CITY OF PRESCOTT ARIZONA
Everybody's Hometown

ADDENDUM NUMBER ONE
to the
PROJECT SPECIFICATIONS
and
CONTRACT DOCUMENTS
for
FY 13 & 14 Water Main Upgrades Phase 1 Project

DATE OF ADDENDUM: **March 13, 2014**

B0945-A

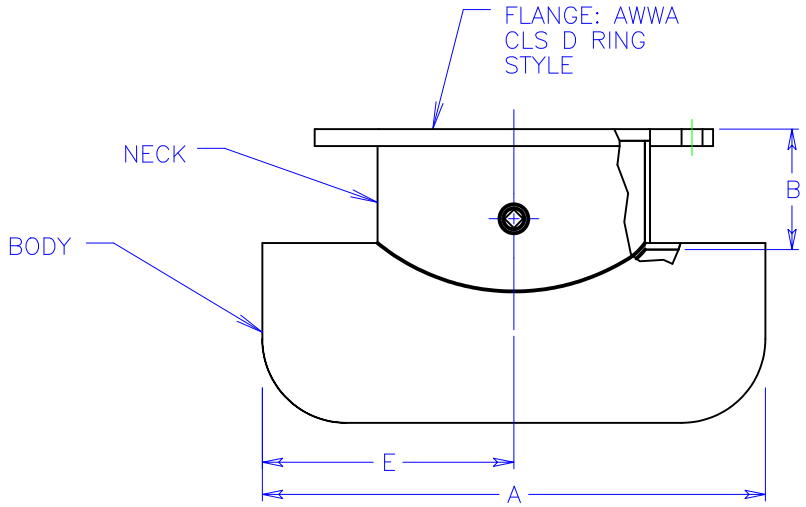
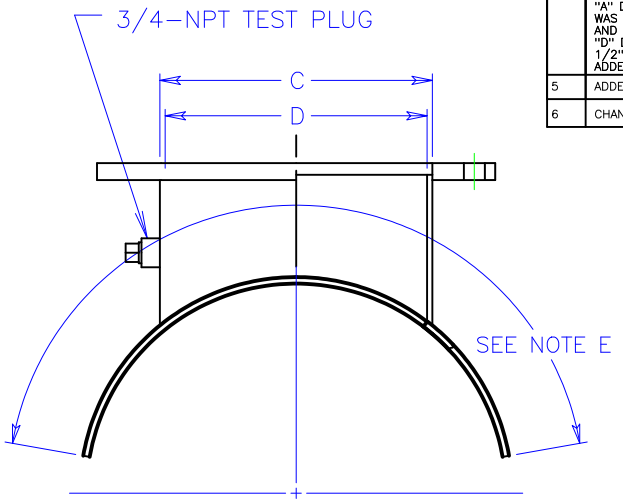
C. The Contractor shall add the cost of this work to the unit price bid in the bidding schedule for custom welded tapping outlet, valve, box and cover. Custom welded tapping outlet shall be a full wrap ROMAC INDUSTRIES, INC. or approved equal and shall be installed in accordance with the manufacturer's recommendations. See attached **Exhibit 'C'** for details and specifications.
